**ZONING AMENDMENT,  
PLANNED UNIT DEVELOPMENT &  
SUBDIVISION STAFF REPORTS**

**Date: April 21, 2005**

**NAME** John F. Loupe

# PLANNING COMMISSION VICINITY MAP - EXISTING ZONING

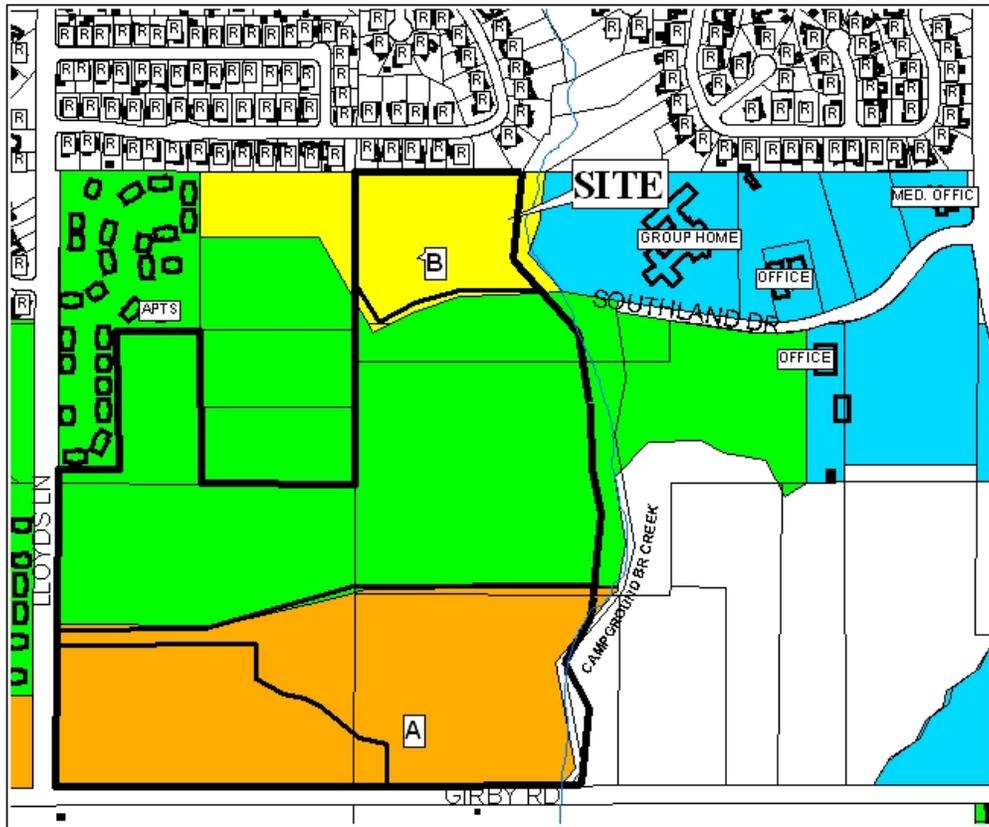
Section V.B.1 of the Subdivision Regulations state that “the street layout shall provide for the future projection into unsubdivided lands adjoining of a sufficient number...to provide convenient circulation.” As illustrated on the Vicinity Map, the site adjoins multiple parcels to the West that are land locked, and the provision of two street stubs, one in the area between Lots 67 and 104 and a second street stub in the area between Lots 138-146, should be required. It should be noted that a street stub is not recommended to the East as the site borders a creek, and the Commission typically has not required street stubs to adjacent properties when the stub adjoins a waterway. Furthermore, street stubs were not required for the subdivision adjacent to the East.

# DETAIL SITE PLAN

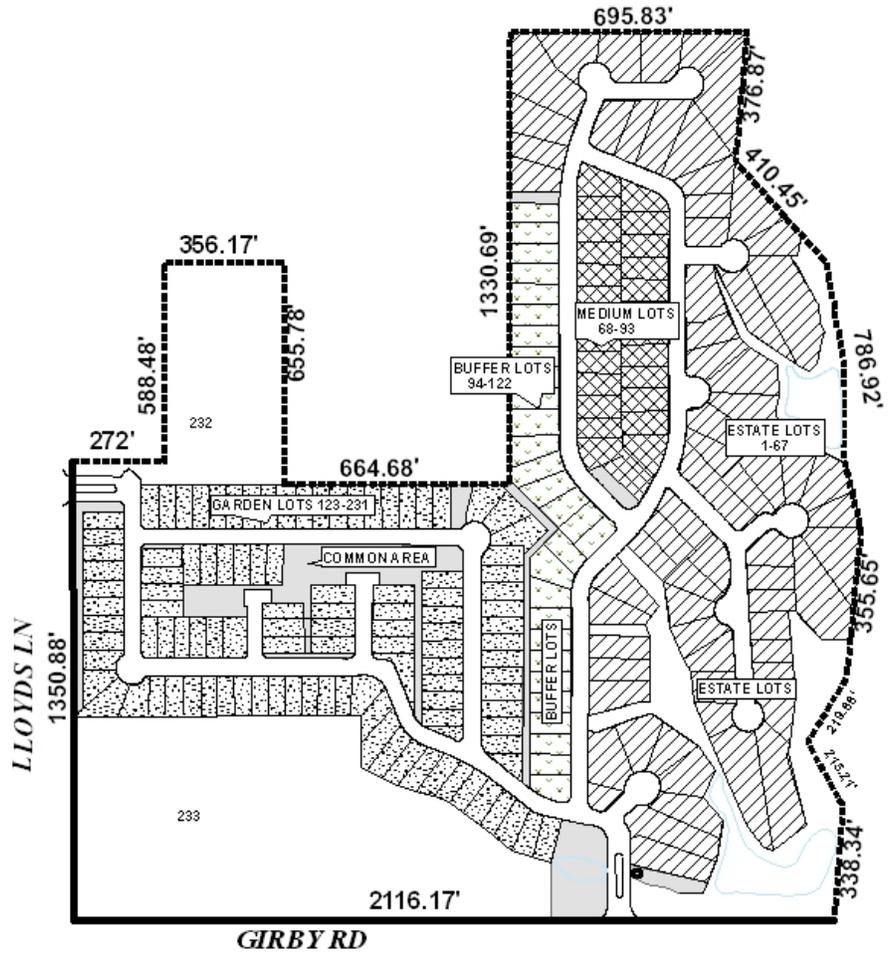
All commercial projects shall comply with the 2003 International Fire Code and Appendices B-G as adopted by the City of Mobile on July 6, 2004. All One- or Two-Family residential developments shall comply with Appendices B, C and D of the 2003 International Fire Code as adopted by the City of Mobile on July 6, 2004. Northwest portion of development should be provided with two means of access. This could be accomplished by providing a road where lots 107 and 136 are located.

The proposed front setbacks vary from 15-feet to 25-feet, and again are typical for residential PUDs; however, the proposed sideyard setbacks for the garden homes are three-feet, two-inches. In approving residential PUDs, even for garden homes, the Commission has typically recommended an eight-foot minimum separation between structures; in this case, that would necessitate a minimum setback of four-feet from the side property lines.

The site adjoins a creek and as such the area may be considered environmentally sensitive; thus the approval of all applicable federal, state and local agencies would be required. Additionally, there are wetlands on the site, some of which encroach into the lots; and while reduced lot widths and sizes are allowed, the applicant should submit documentation prior to the recording of the final plat, which illustrates that there is adequate buildable area (6,000 square feet based on the minimum garden home lots) for those lots containing wetlands.

**Planned Unit Development:** Based upon the preceding, this application is recommended for approval subject to the following conditions: 1) full compliance with the Traffic Engineering Comments (driveway number, size, location and design to be approved by Traffic Engineering and conform to AASHTO standards, traffic calming measures should be included in development); 2) the provision of street stubs to the landlocked parcels to the West in the vicinity of Lots 67-104 and Lots 138-146; 3) that the applicant obtain all necessary federal, state and local permits; 4) completion of the rezoning process (to R-2) for the entire site; and 5) full compliance with all municipal codes and ordinances.

**Subdivision:** With a waiver of Section V.D.2., the plat will meet the minimum requirements of the Subdivision Regulations and is recommended for Tentative Approval subject to the following conditions: 1) full compliance with the Traffic Engineering Comments (driveway number, size, location and design to be approved by Traffic Engineering and conform to AASHTO standards, traffic calming measures should be included in development); 2) the provision of street stubs to the landlocked parcels to the West in the vicinity of Lots 67-104 and Lots 138-146; 3) that the applicant obtain all necessary federal, state and local permits; 4) completion of the rezoning process (to R-2) for the entire site; and 5) full compliance with all municipal codes and ordinances.
